DART AEROSPACE LTD		Work Order:	136983
Description: Crosstube Assembly, Mid Fwd		Part Number:	D206-667-147
Inspection Dwg: D206-667-147 Rev: A		Page 1 of 2

DART AEROSPACE LTD HAWKESBURY, ONTARIO, CANADA	
DRAWING NO. D206-667-147	REV. A SHEET 1 OF 4
TITLE CROSSTUBE ASSY (206L MID FWD)	SCALE NTS
COPYRIGHT © 2010 BY DART AEROSPACE LTD THIS DOCUMENT IS PRIVATE AND CONFIDENTIAL AND IS SUPPLIED ON THE EXPRESS UNDERSTANDING THAT IT IS NOT TO BE USED FOR ANY PURPOSE OR REPRODUCED OR COMMUNICATED TO ANY OTHER PERSON WITHOUT WRITTEN PERMISSION FROM DART AEROSPACE LTD.

DRAWING NO. D206-667-147	TITLE CROSSTUBE ASS'Y (206L MID FWD)	REV. A	DART AEROSPACE LTD ENGINEERING ORDER		D.E.O. NO. D206-667-147-A-1	SHEET NO. SHEET 1 OF 1	SCALE NTS
DRAWN <i>q2</i>	CHECKED <i>ASS</i>	MFG. APPR. <i>JB</i>	APPROVED <i>MD</i>		DE APPR. <i>MD</i>		
DATE 11.07.15	DATE 11.07.20	DATE 11.07.21	DATE 11/07/21		DATE 11.07.21

DRAWING NO. D206-667-147		TITLE CROSSTUBE ASS'Y (206L MID FWD)		REV. A		DART AEROSPACE LTD ENGINEERING ORDER		D.E.O. NO. D206-667-147-A-2		SHEET NO. SHEET 1 OF 1		SCALE NTS	
DRAWN AJS		CHECKED		MFG. APPR.		APPROVED		DE APPR.		DATE 12.08.02			
DATE 12.08.02		DATE 12.08.02		DATE 12.08.02		DATE 12.

DETAIL P
BONDING STRAP INSTALLATION 2 PL

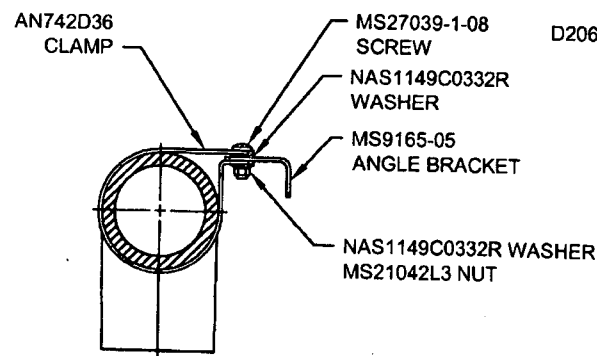
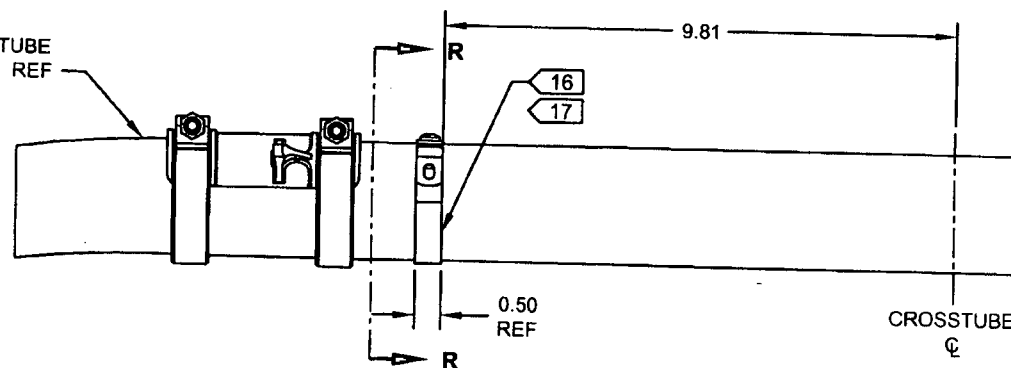
ADD ELECTRICAL GROUNDING STRAP

- 16) MASK AREA UNDER CLAMP PRIOR TO PAINTING
- 17) SEAL EDGES WHERE AN742D36 CLAMP MEETS WITH THE CROSSTUBE USING SIKAFLEX-241/-291 OR MIL-S-8802 CLASS B2 OR PROSEAL 890 SEALANT
- 18) PERFORM RESISTANCE CHECK TO ENSURE MAX RESISTANCE IS 10 MILLIOHMS

ITEM	QTY -147	PART NUMBER	DESCRIPTION
1	X	D206-667-147	CROSSTUBE ASSEMBLY (206L MID FWD)
10	2	AN742D36	CLAMP
11	2	MS9165-05	ANGLE BRACKET
12	2	MS21042L3	NUT (OR MS21042-3)
13	2	MS27039-1-08	SCREW
14	4	NAS1149C0332R	WASHER (OR AN960C10L)
